ADA Curb Ramp New Construction Inspection Form (Combination)

NW 307th

23885.56

NW Pacific

COMBINATION RAMP (C)

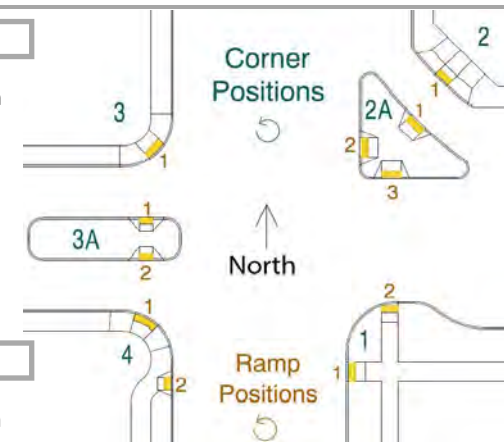
☐

☒

8.6

☒

☒

5.2

☒

☒

☒

☒

RR2/RR3 clear width 74', IITD
